Changes at the end of the foldable rigidifying push bar

ECN-00003591

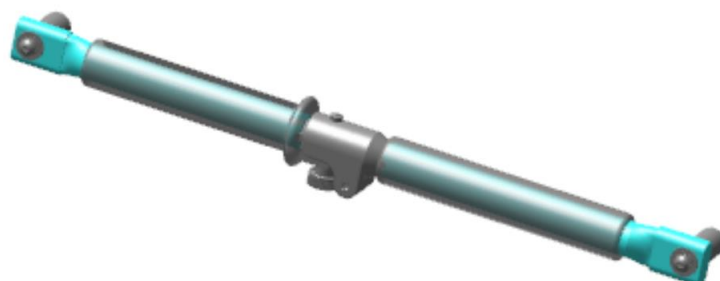
- ✓ The end of the foldable rigidifying push bar has been changed with a rectangular tube plug instead of the coating on surface.
- ✓ The updated version is backward compatible with the existing one.
- ✓ The updated version was implemented by the batch of serial no. TM22-070840.
- ✓ The updated version was implemented on KM-5000.2, KM-5001 and KM-BT10.
